# BCA ASSESSMENT REPORT

*12-16 Bent Street, Lindfield*

Project Number: 116856

Date: 10 March 2025

**Figure 4:** South elevation

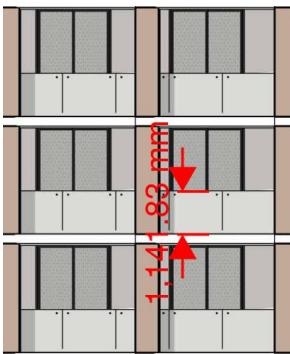
The development is Type A Construction and BCA Clause C3D7 requires suitable vertical and/or horizontal spandrel separation between the openings in the external walls on different storeys. The plans indicate suitable spandrels have not been provided by a combination of horizontal balcony slabs which achieve 1100mm length and external walls beneath windows which have a minimum of 900mm high with 600mm above the slab, therefore not complying with this Clause. **Following options apply:**

- + Amend design to suit compliance requirement, or
- + Fire Safety Engineer to review and confirm if a performance solution is feasible (BCA Clause C3D7).
- + **As the proposed development is over 25m, sprinklers are therefore required. If the proposed building is provided with a AS 2118.1:2017 sprinkler system installed throughout; spandrels are therefore not required.**

Figure 5: Level 01

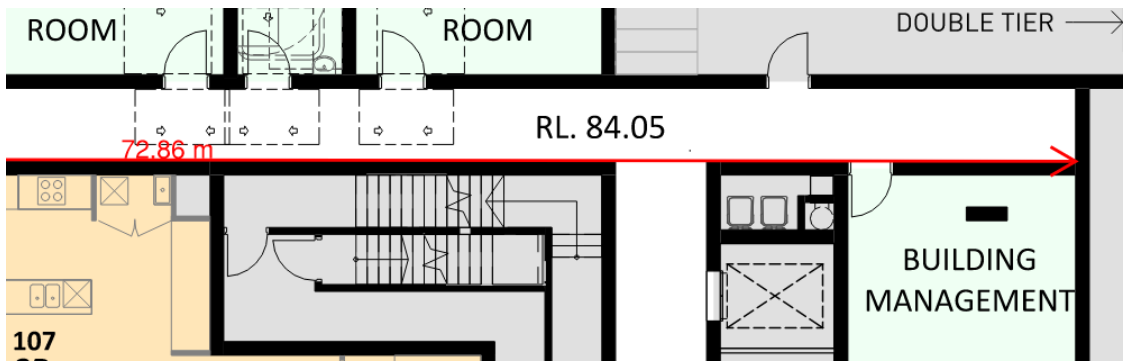
In accordance with BCA Clause C3D15, in a Class 2 or 3 building, a public corridor if more than 40 m in length, must be divided at intervals of not more than 40 m with smoke-proof walls complying with S11C2. The smoke corridors located on Levels 01, 09 and 10 have a length greater than 40m, therefore not complying with Clause. Design amendments required to achieve compliance, must be divided at intervals of not more than 40m.

**Figure 8:** Ground Level Fire Isolated exit

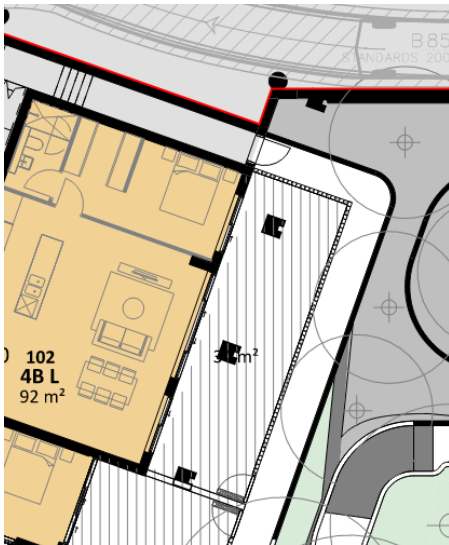
As the path of travel from the point of discharge of the fire isolated exits on the Ground Floor and Level 01 pass within 6m of an external wall of any part of an external wall of the same building, it must therefore be protected in accordance with BCA Clause C4D5 by either:

- + Internal or external wall-wetting sprinklers as appropriate used with windows that are automatic closing or permanently fixed in the closed position; or
- + –/60/– fire windows that are automatic closing or permanently fixed in the closed position; or
- + –/60/– automatic closing fire shutters or

**Alternatively, (if feasible) a fire engineered performance solution would be required (BCA Clause C4D5).**

Figure 12: Entrance doorway Level 01    Figure 13: Entrance doorway Level 02

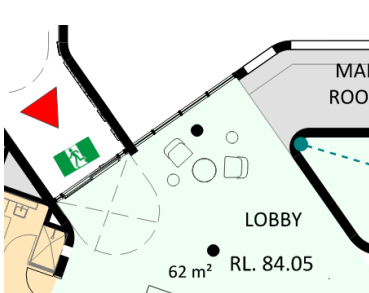
In accordance with BCA Clause D3D24 a doorway serving as a required exit or forming part of a required exit must not be fitted with a sliding door unless it leads directly to a road or open space and the door is able to be opened manually under a force of not more than 110 N and be openable under fire trip. **Further information of door hardware is required for assessment for Communal corridor doorways located on Level 01 and Level 02. Fire Engineering may be required at the CC stage.**

Figure 14: Threshold ramp Level 01

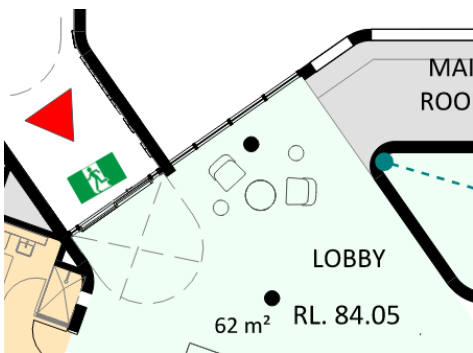
BCA Clause D3D16 requires that a threshold of a doorway must not incorporate a step or ramp at any point closer to the doorway than the width of the door leaf unless a building is required to be accessible. **Further information of the gradient of the threshold ramps is required for assessment for the Communal corridor doorways located on Level 01 and Level 02.**

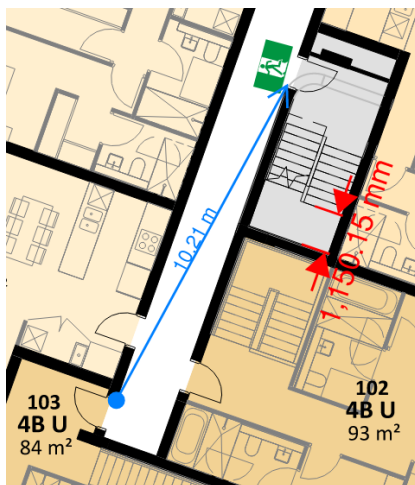
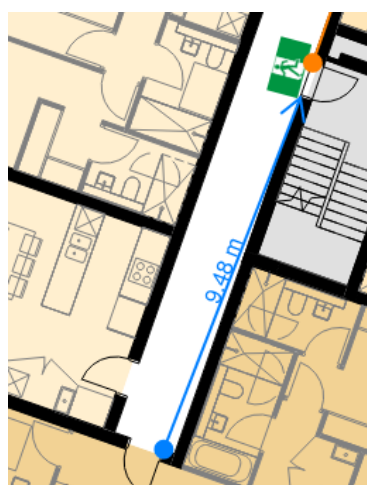
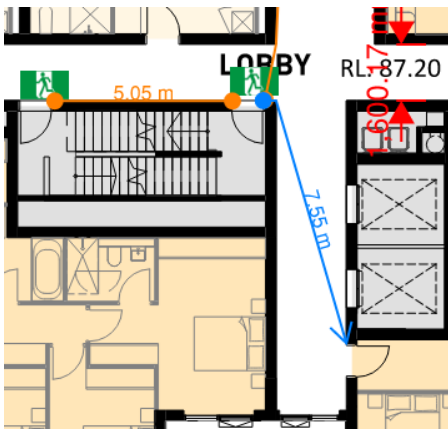
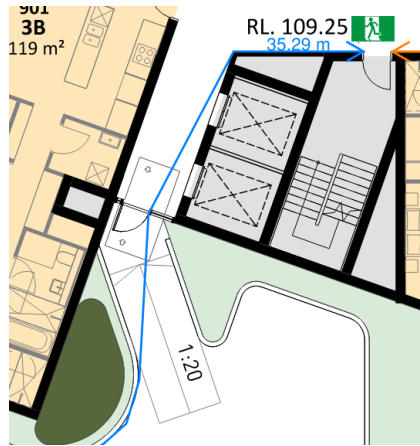
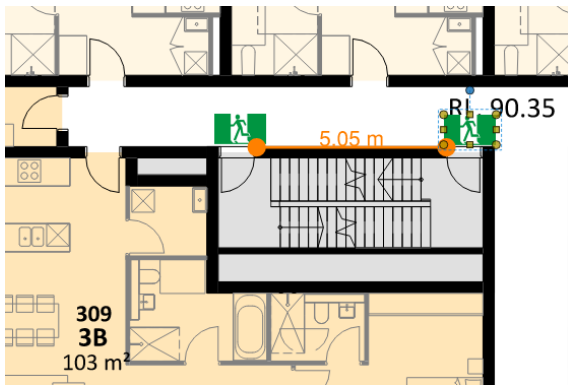
It will be necessary to undertake a Fire Engineered Performance Solution to permit the extended travel distances within the following locations:

- + BCA Clause D2D5 – Exit travel distance
  - o To permit an exit travel distance of up to 11m in lieu of 6m within Level 01 to Level 03.
  - o To permit an exit travel distance of up to 10m in lieu of 6m within Level 04 to Level 05.
  - o To permit an exit travel distance of up to 8m in lieu of 6m within Level 02 to Level 09.
  - o To permit an exit travel distance of up to 36m in lieu of 20m within Communal Space Level 09.
- + BCA Clause D2D6 – Distance between alternative exits
  - o To permit an exit travel distance between alternative exits of up to 6m in lieu of the minimum requirement of 9m for Levels 02 to Levels 10.

**Figure 23:** Level 01 Fire Pump room

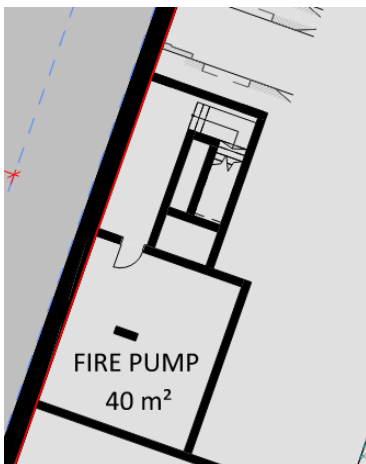
In accordance with BCA Clause E1D2 and AS 2419 an internal pump room shall have door that directly leads to an airlock that leads to a fire isolated passageway or stair. The fire pump room located on Basement Level 01 does not have an airlock and leads directly into a stairway which is not fire-isolated. This stair is to be fire-isolated and provided with an airlock outside the pump room. Design to illustrate compliance.

Figure 24: Level 02

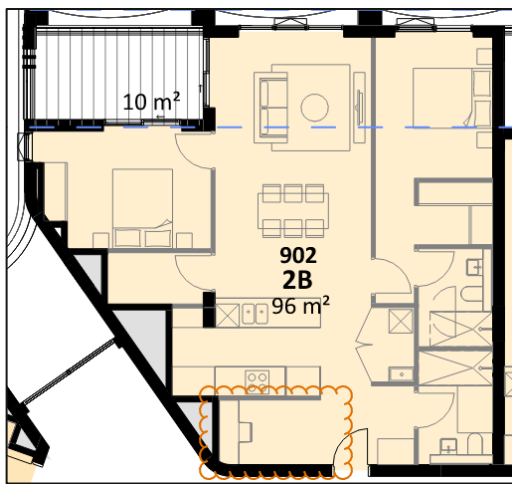
In accordance with BCA Clause F6D2 and F6D3 natural light is required to all habitable rooms within a Class 2 building, with the area of the doors and windows (exclusive of any framing members, glazing bars or other obstructions) required to be not less than 10% of the floor area. The plans have been assessed which reveals not all habitable spaces are served by windows or glazed doors. The area of concern are the study nooks provided within the SOU's which have not been provided with any natural lighting, therefore not complying with this Clause. Design amendments are required to achieve compliance.

**Figure 26:** Level 04

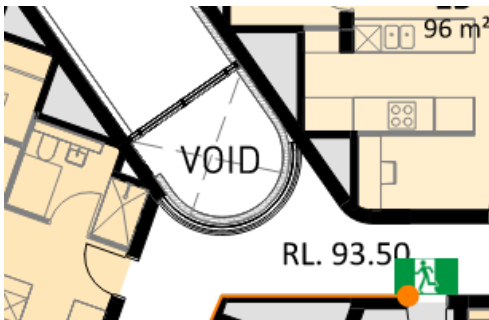
As the proposed development consists of an atrium, BCA Part G3 Atrium construction, requires an atrium to be separated from the remainder of the building, have a horizontal diameter less than 6m, bounding wall construction and fire and smoke control systems. Proposed Atrium is to be reviewed by the project Fire Safety Engineer.
